**TOWN OF NEWBURGH  
PLANNING BOARD  
TECHNICAL REVIEW COMMENTS**

**PROJECT NAME:** GARDNER RIDGE  
**PROJECT NO.:** 2002-29  
**PROJECT LOCATION:** GARDNERTOWN ROAD NEAR GIDNEY AVENUE  
SECTION 75, BLOCK 1, LOT 4.12  
**REVIEW DATE:** 9 SEPTEMBER 2022  
**MEETING DATE:** 15 SEPTEMBER 2022  
**PROJECT REPRESENTATIVE:** THOMAS B. OLLEY, P.E., P.L.L.C.

ROCK REMOVAL PLAN  
**GARDNER RIDGE**  
**GARDNERTOWN ROAD**  
 TOWN OF NEWBURGH, ORANGE COUNTY, NY

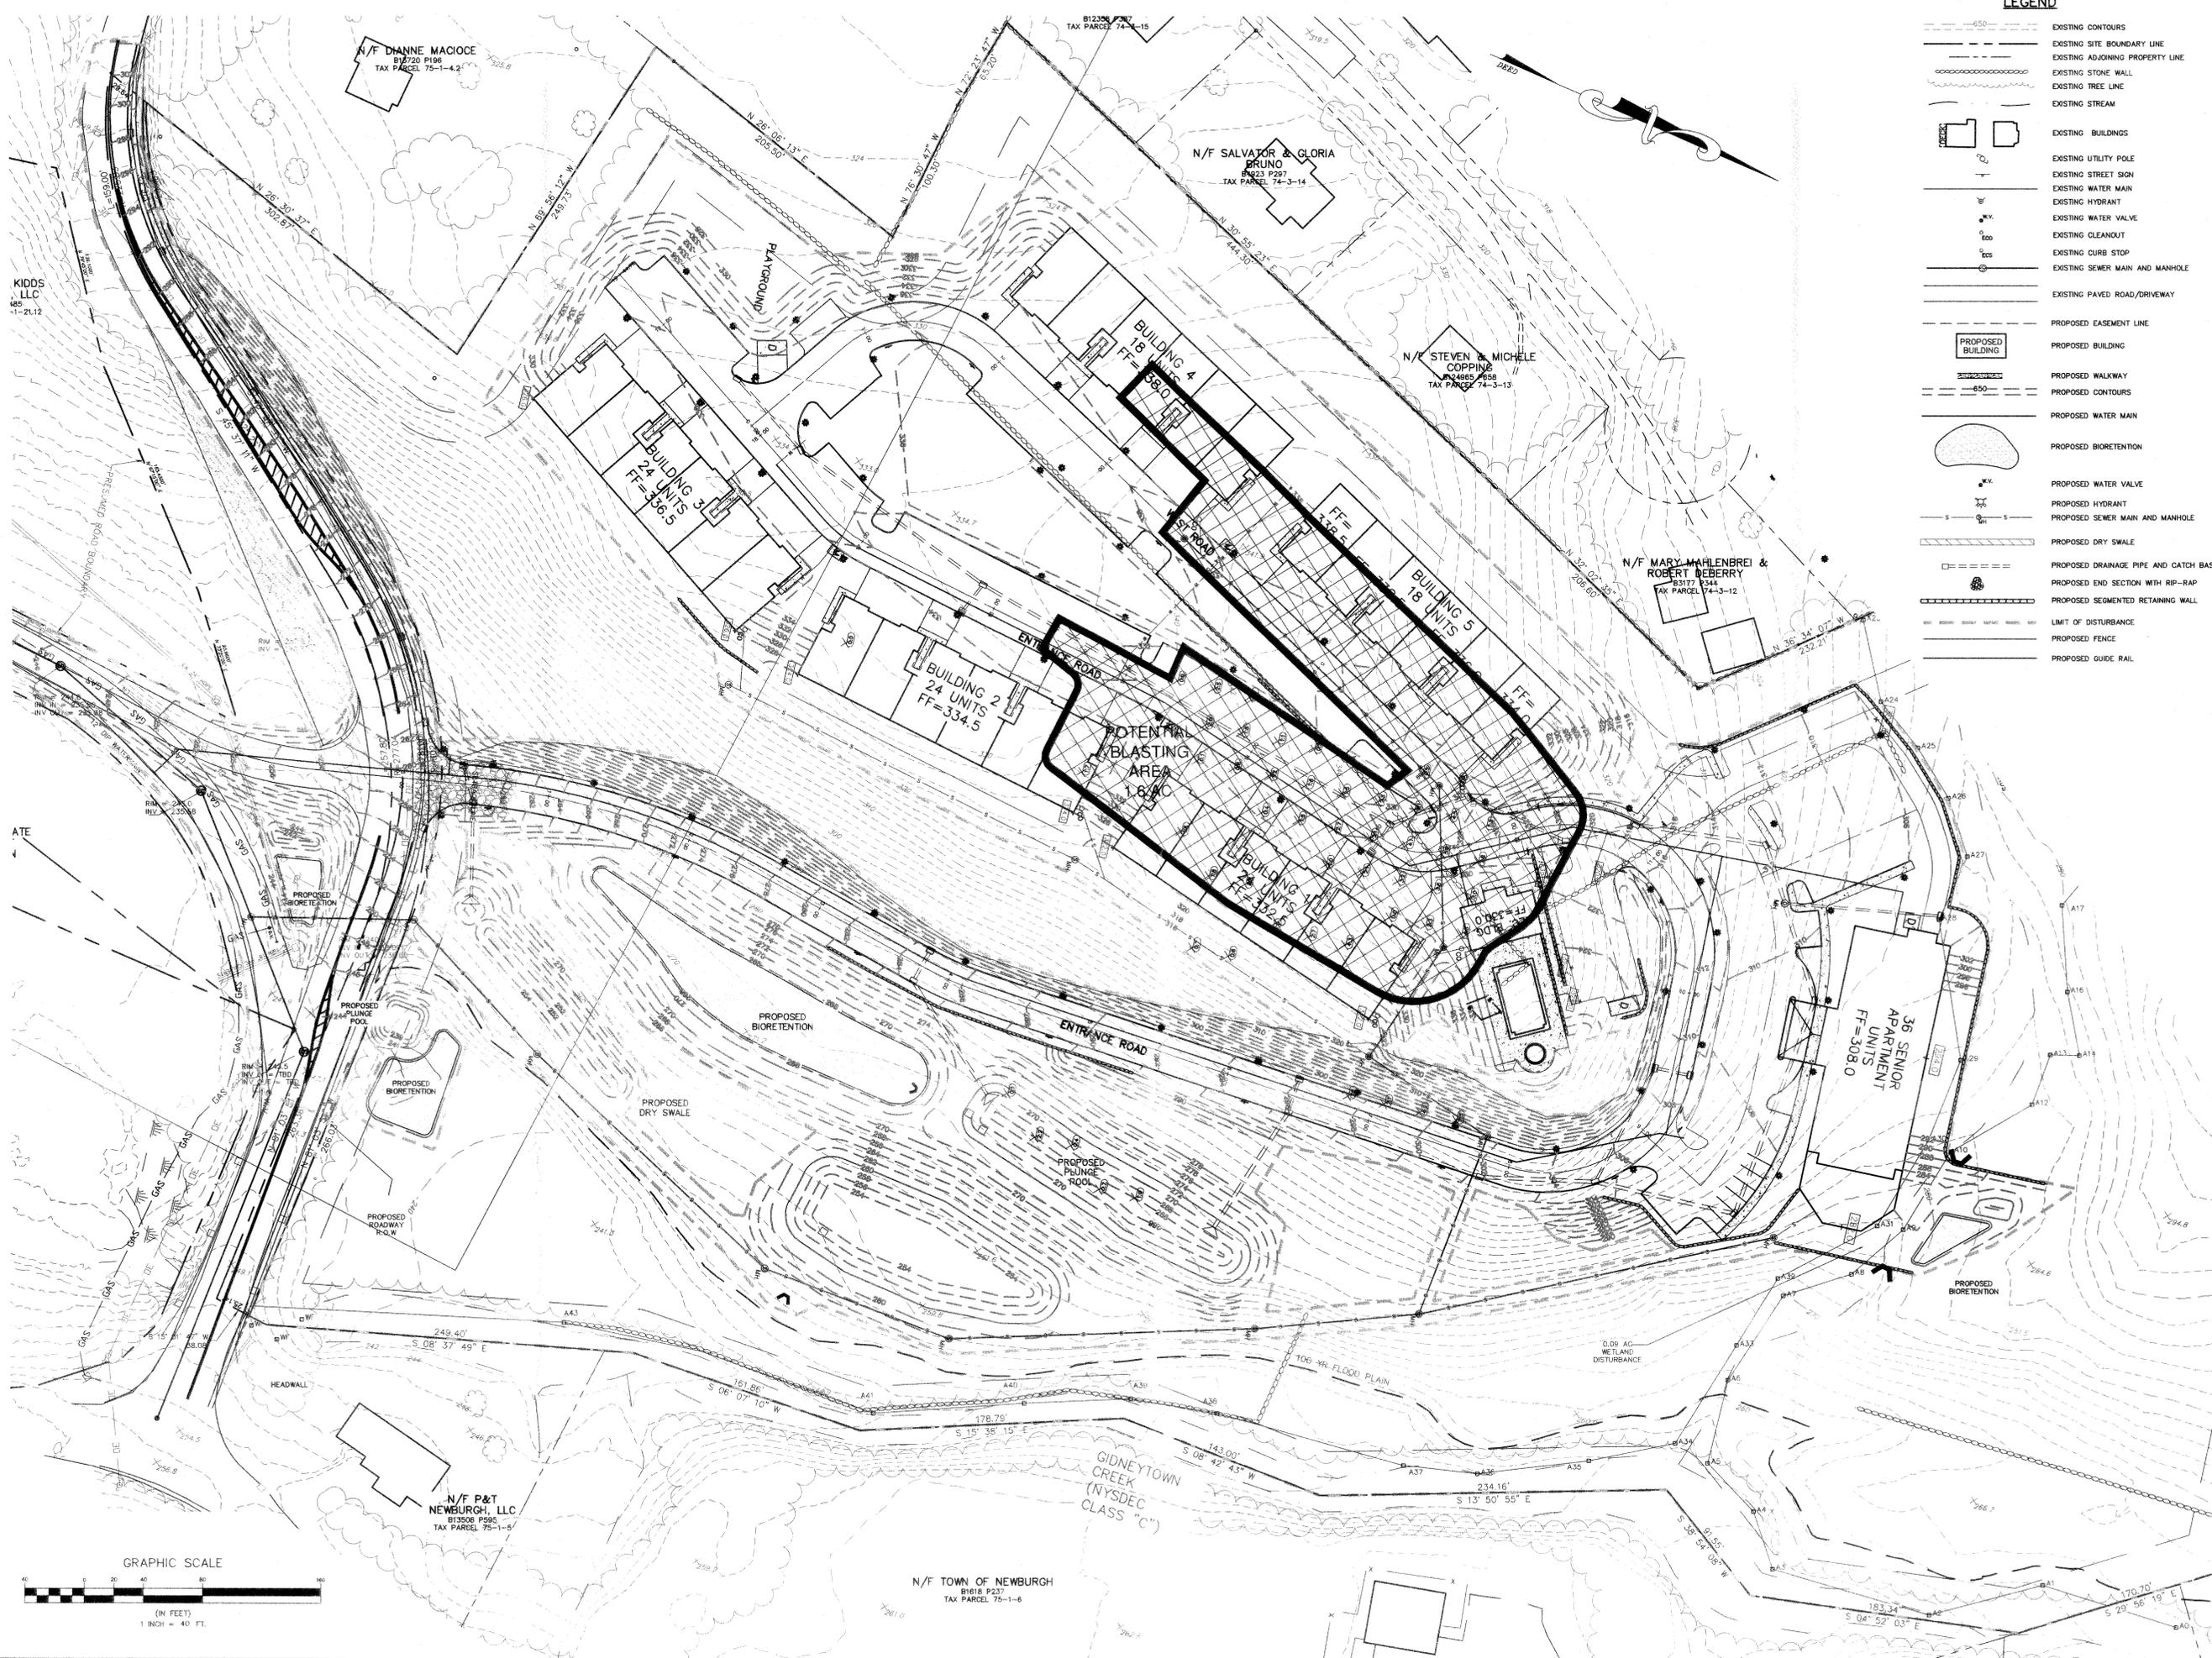
2. A revised SWPPP has been received and is under review by this office.
3. A revised Rock Removal Plan has been submitted dated June 2022. This plan has identified a significant reduction (3 acres to 1.6 acre) in the amount of area proposed for rock removal.

**STORMWATER MANAGEMENT BASIN ACCESS DRIVE DETAIL**  
NOT TO SCALE

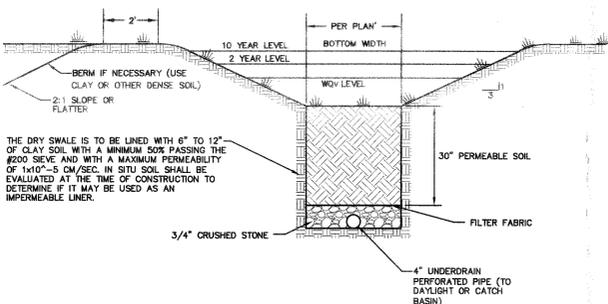
11. Mechanism to limit the depth within bioretention areas to the maximum 6inch depth should be addressed.
12. An access road detail is depicted for operation and maintenance of the Stormwater Management Facilities. Location of these access roads should be depicted on the plans.
13. All Stormwater Facilities which contain standing water must be fenced in accordance with Town Code. Fencing should be depicted in plan in detail.
14. The applicants should discuss the status of the SEQRA review and determinations for this project. A revised EAF dated 5 June 2022 has been submitted. It is noted the revised EAF is not signed.

**BIORETENTION SYSTEM DETAIL**  
NOT TO SCALE

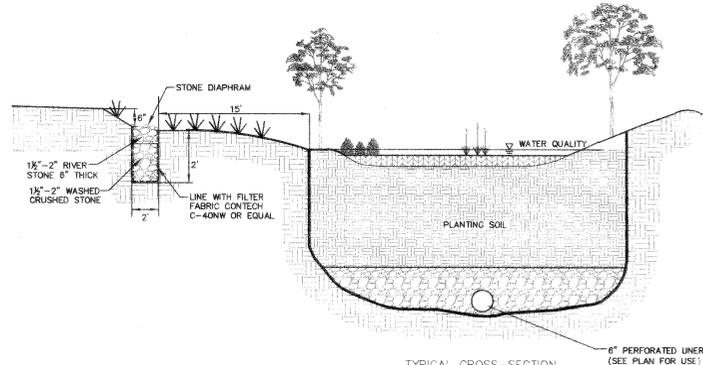
10. Outlets from proposed bioretention areas should be depicted on plans. Bioretention areas are depicted in detail as having under drains.
